UNITED STATES
NUCLEAR REGULATORY COMMISSION
WASHINGTON, D.C. 20555-0001

SUBJECT: SUSQUEHANNA STEAM ELECTRIC STATION, UNITS 1 AND 2 – STAFF ASSESSMENT OF RESPONSE TO 10 CFR 50.54(f) INFORMATION REQUEST – FLOOD-CAUSING MECHANISM REEVALUATION (CAC NOS. MF6037 AND MF6038)

STAFF ASSESSMENT BY THE OFFICE OF NUCLEAR REACTOR REGULATION
RELATED TO FLOODING HAZARD REEVALUATION REPORT
NEAR-TERM TASK FORCE RECOMMENDATION 2.1
SUSQUEHANNA STEAM ELECTRIC STATION, UNITS 1 AND 2
DOCKET NOS. 50-387 AND 50-388

Figure 3.1-2 Site Area Map of the SSES site (derived from Susquehanna, 2015a)

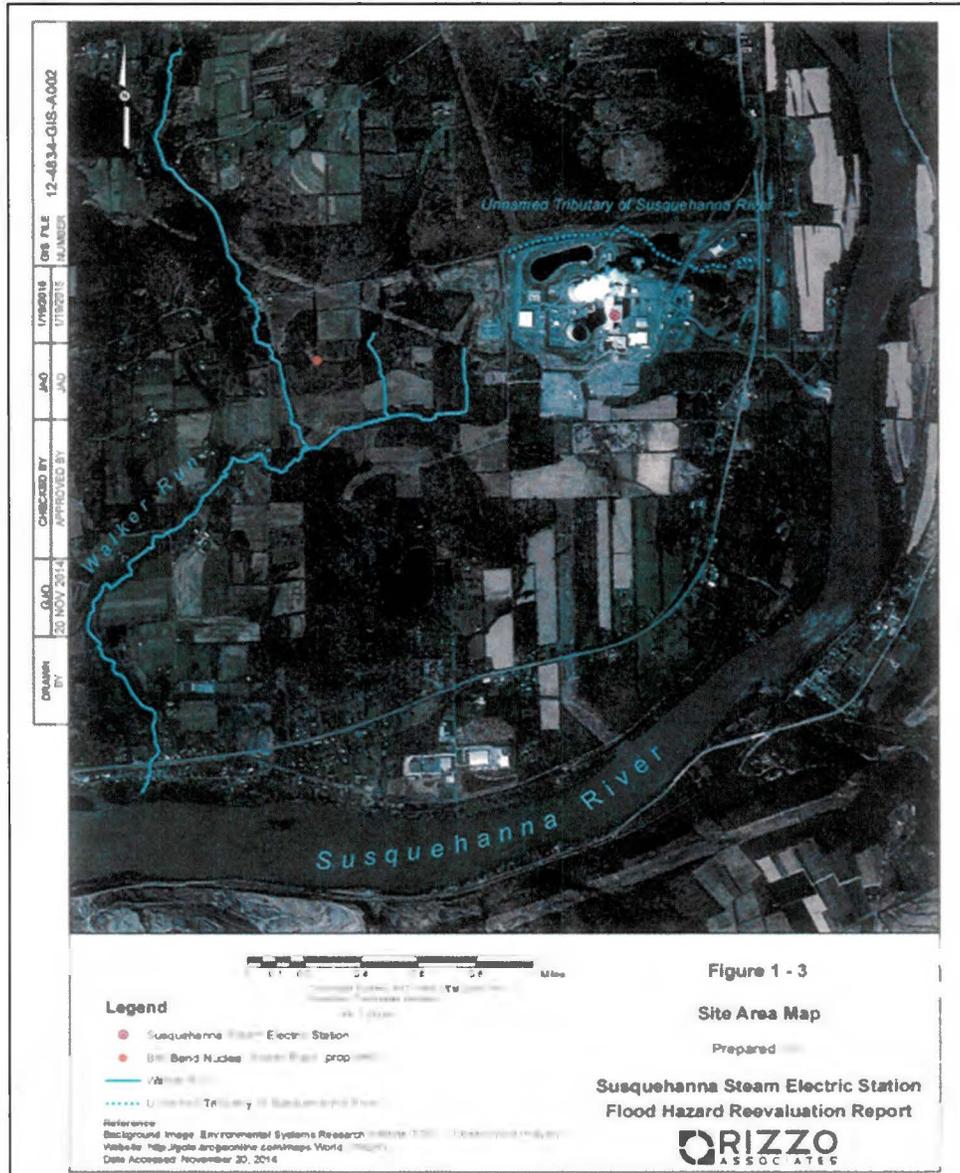
The Susquehanna site (Figure 3.1-2) is situated on a plateau, sloping to the east towards the Susquehanna River. Approaching the river, the topography is steep, with the elevation dropping quickly. Near the site, small tributaries drain small areas into the Susquehanna River. The largest tributary, named Walker Run drains an area of 4.3 mi² (11.1 km²) two miles southwest of the site.

Due to the large difference in scale between the two (Figure 3.1-2), the licensee treated the flooding hazards from the Susquehanna River and Walker Run separately.

Figure 3.1-3 Present Day Layout of SSES site (derived from Susquehanna, 2015a)

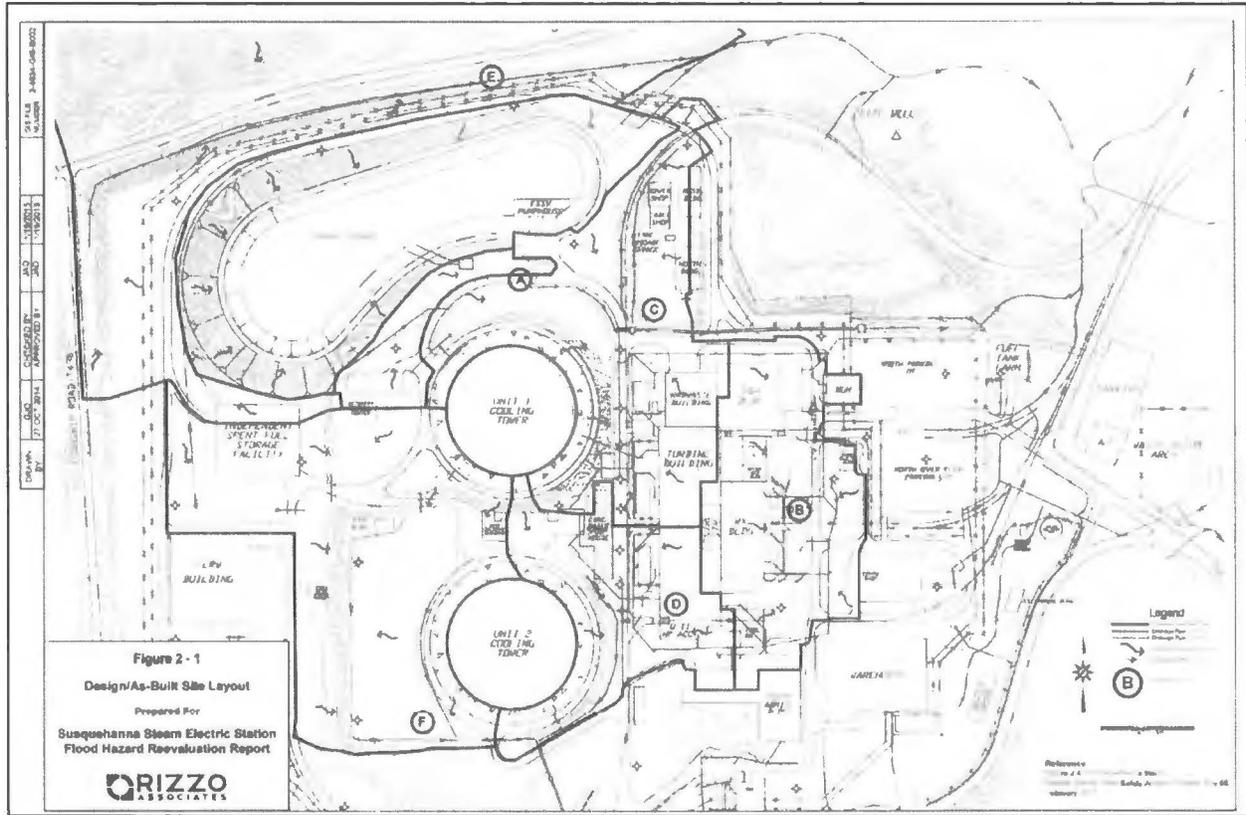
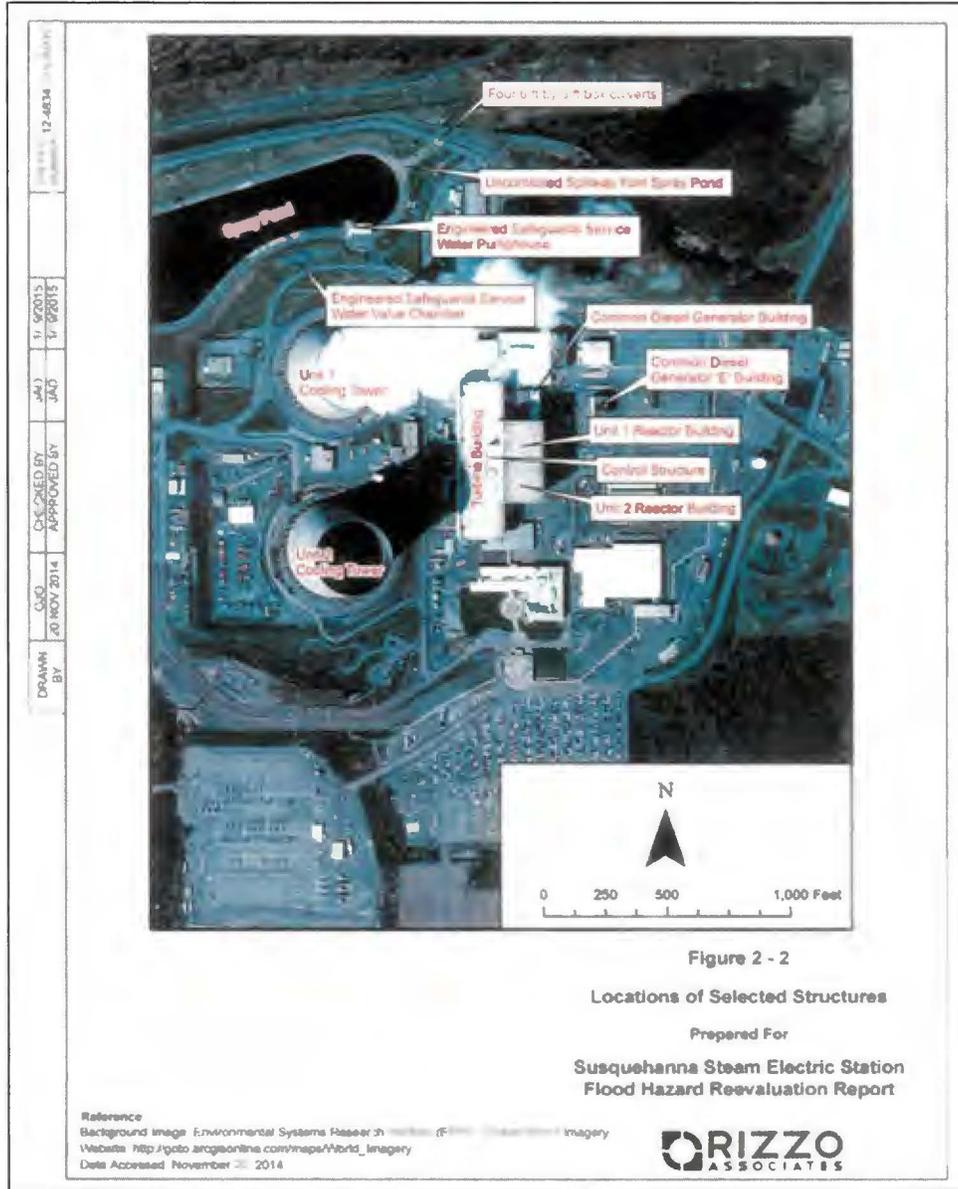
The CDB for Susquehanna includes the combination of LIP and wind-wave generated run-up in the spray pond. The spray pond is located on the northwest side of the Susquehanna site (Figure 3.1-3 and Figure 3.1-4). The licensee reevaluated this hazard combination assuming the drainage culverts were blocked and determined that the maximum reevaluated still water level in the spray pond under LIP conditions would be 682.02 ft (207.880 m) MSL. Using methods found in the U.S. Army Corps of Engineers (USACE) Coastal Engineering Manual (CEM) (USACE 2011), wind wave run-up values were calculated at the embankment to be 1.3 ft

(0.40 m) and 2.3 ft (0.70 m) at the ESSW pumphouse, giving a total flood elevation of 683.3 ft (208.27 m) MSL at the embankment and 684.3 ft (208.57 m) MSL the pumphouse. The licensee stated that these two flood levels have no impact on the spray pond or the ESSW pumphouse since the top of the spray pond embankment is at elevation 685.5 ft (208.94 m) MSL.

The NRC staff considered the USACE CEM methodology used by the licensee and reviewed the parameter values used to calculate the maximum wave runup such as fetch length, wave run up reduction factors, and significant wave height. The NRC staff independently calculated the wave run-up, obtaining the same result as the licensee. The NRC staff finds that both the approach and parameter values used are appropriate and reasonable.

Figure 3.2-1 Selected Precipitation Hyetograph with Peak Value after 2/3 of LIP Event (derived from Susquehanna, 2015a)

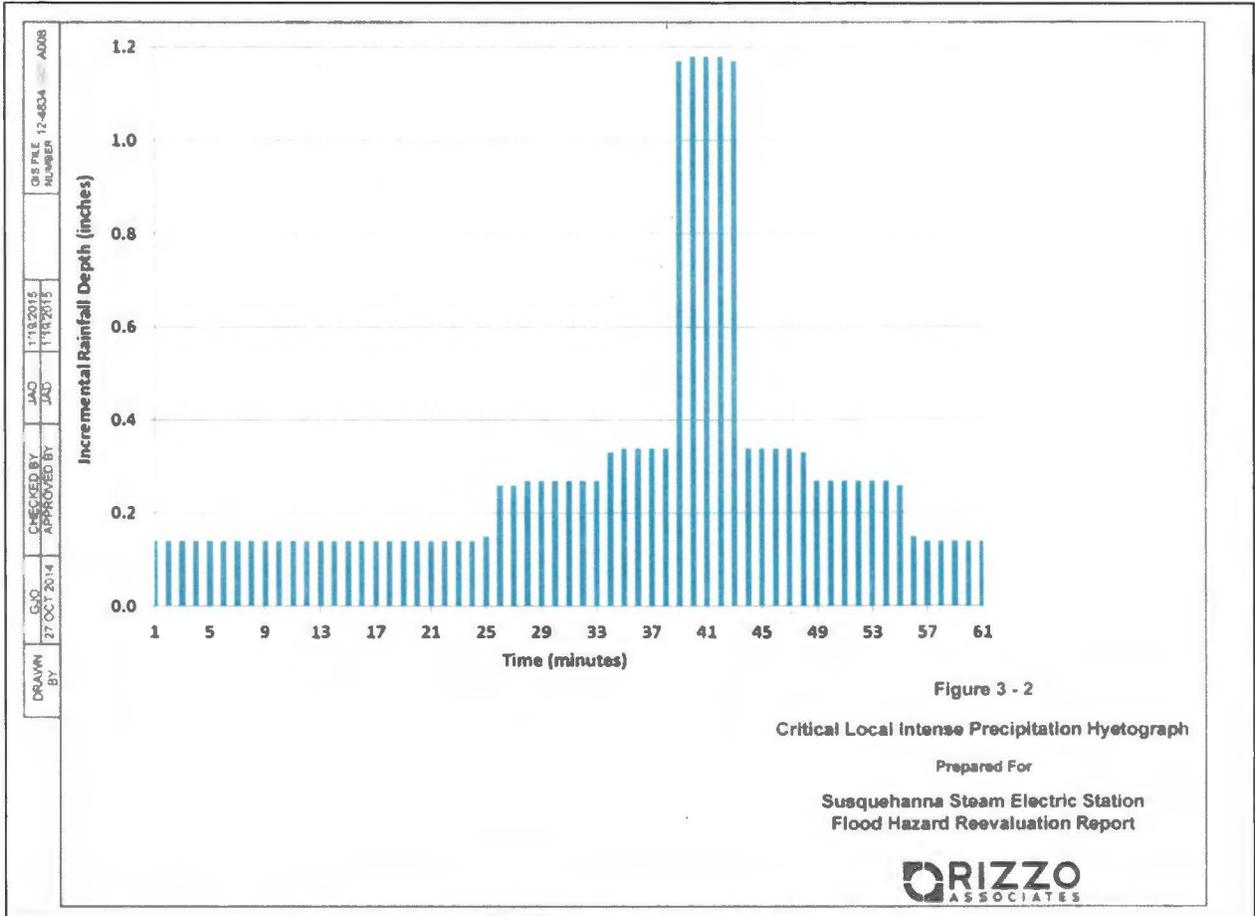
In addition, the licensee assumed that the peak intensity of the LIP occurs at the two-thirds point of the event as shown on Figure 3.2-1.

PMP depth of 17.5 inches (0.445 m). The licensee varied the timing of the peak precipitation and determined that using the PMP distribution with the peak at the two-thirds point of the event yielded the highest flood elevation.

The NRC staff independently determined the 1-hour, 1 mi² (3 km²) PMP for the Susquehanna site using HMR 52 (NOAA, 1982) and found it to be in agreement with the licensee. Based on the location of the site and the NRC staff's independent estimate of the 1-hour 1 mi² (3 km²) PMP, the NRC staff considers the licensee's response to be reasonable.

Figure 3.2-2 Inundation Map of the SSES site for Local Intense Precipitation (derived from Susquehanna, 2015a)

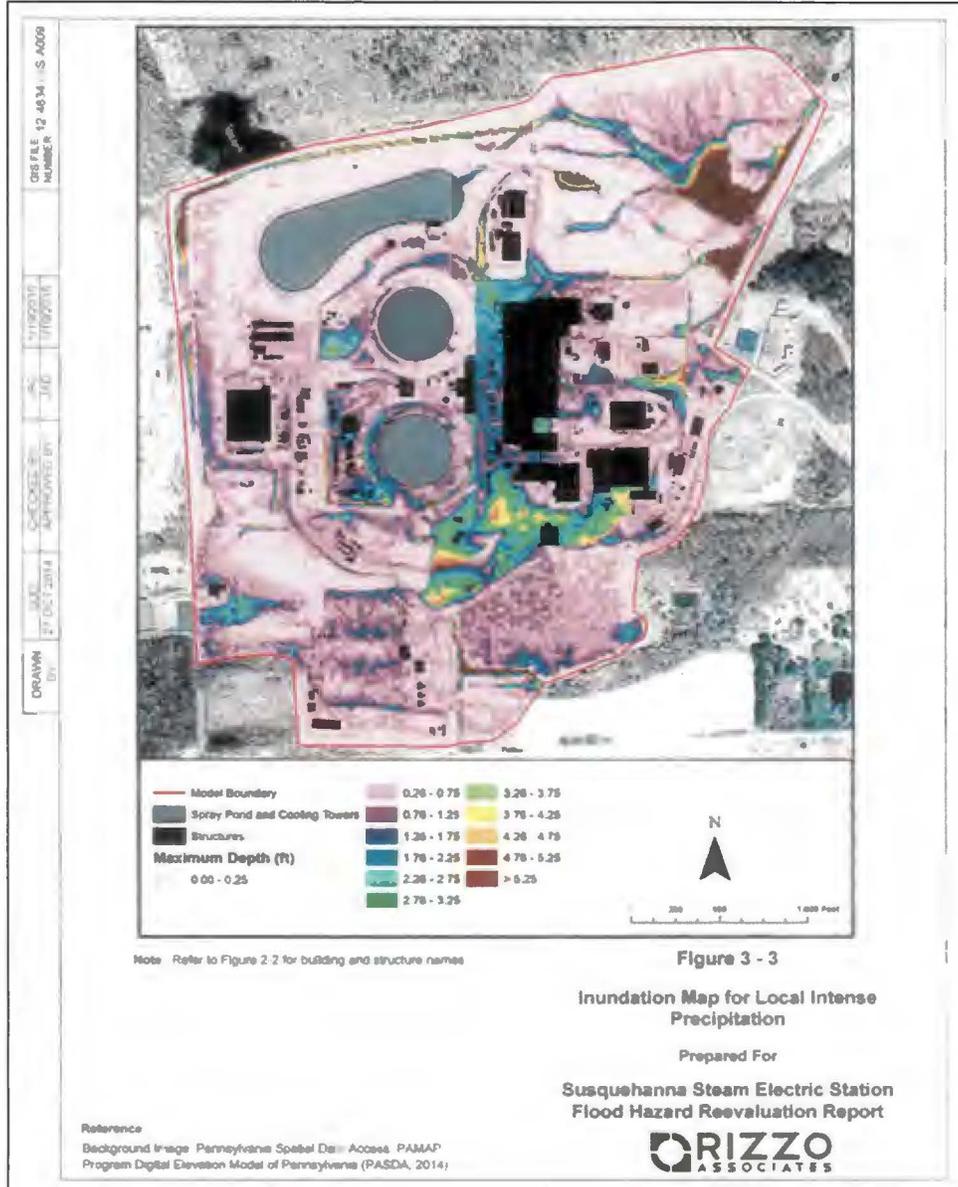
The licensee reported the maximum water surface elevation and the available freeboard for eight different onsite locations in the Susquehanna FHRR (Susquehanna, 2015a). Inundation of the plant area is shown in Figure 3.2-2.

The licensee determined that ponding depths in the vicinity of safety-related buildings ranged from 0.31 ft (0.094 m) at the engineered safeguard service water (ESSW) pumphouse to 1.61 ft (0.491 m) near the Unit 1 and Unit 2 reactor buildings. Additionally, the licensee stated that no detailed structural analysis of safety-related buildings were required due to the shallow depth of inundation.

The NRC staff evaluated the FLO-2D results provided by the licensee, and ran three scenarios with FLO-2D Build 14.11.09 to evaluate the performance and stability of the licensee's model. The NRC staff confirmed that the maximum water surface elevation is obtained from the two-thirds back loaded LIP distribution. The rainfall distribution is shown in Figure 3.2-1. The maximum difference in the licensee's results and the NRC staff's was 0.2 ft (0.06 m) on the west side of the turbine building. The NRC staff considers this difference negligible and attributes the difference to the use of the second topographic model and a different FLO-2D Build Number. The NRC staff found that the FLO-2D model conserves volume and maintains numerical stability with no surging of velocities or flood levels.

Figure 3.4-1 Inundation Map of the SSES site for Scenario 1 of the Cooling Tower Basin Breach (derived from Susquehanna, 2015a)

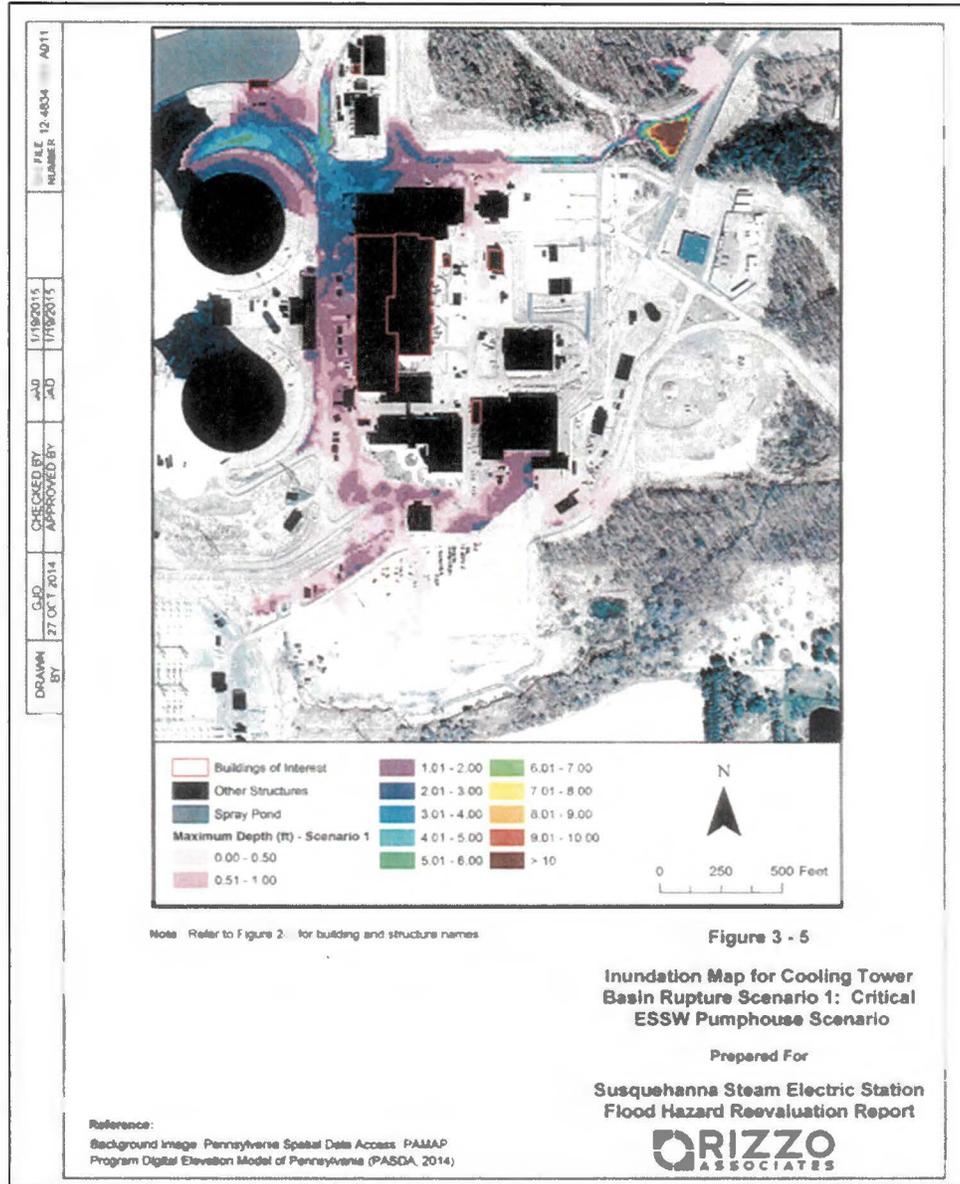
The licensee stated that the ESSW pumphouse would be the only safety-related structure that would be inundated by any breaching scenario of the cooling tower basin. The licensee stated that scenario 1 (Figure 3.4-1) resulted in the highest flood levels at the ESSW under this scenario, with the south side of the ESSW pumphouse would be inundated by 1.45 ft (0.442 m).

Figure 3.4-2 Inundation Map of the SSES site for Scenario 4 of the Cooling Tower Basin Breach (derived from Susquehanna, 2015a)

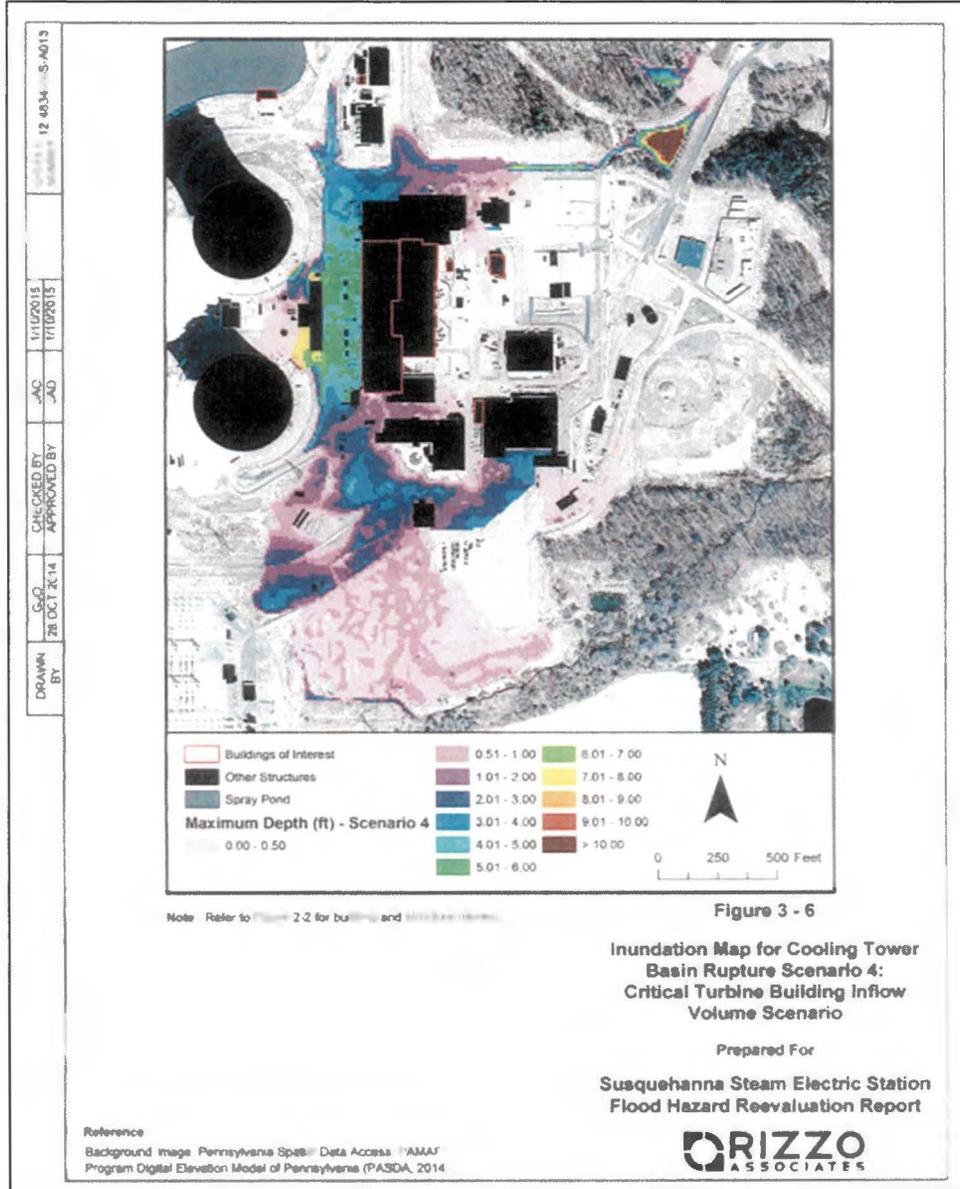
Scenario 4 (Figure 3.4-2) resulted in the highest amount of flow into the turbine building. The turbine building would be flooded internally with approximately 3.1 million gallons of water. As mentioned previously, the turbine building can store approximately 9.9 million gallons of water below elevation 678 ft (206.7 m) before affecting the safety-related SSCs.
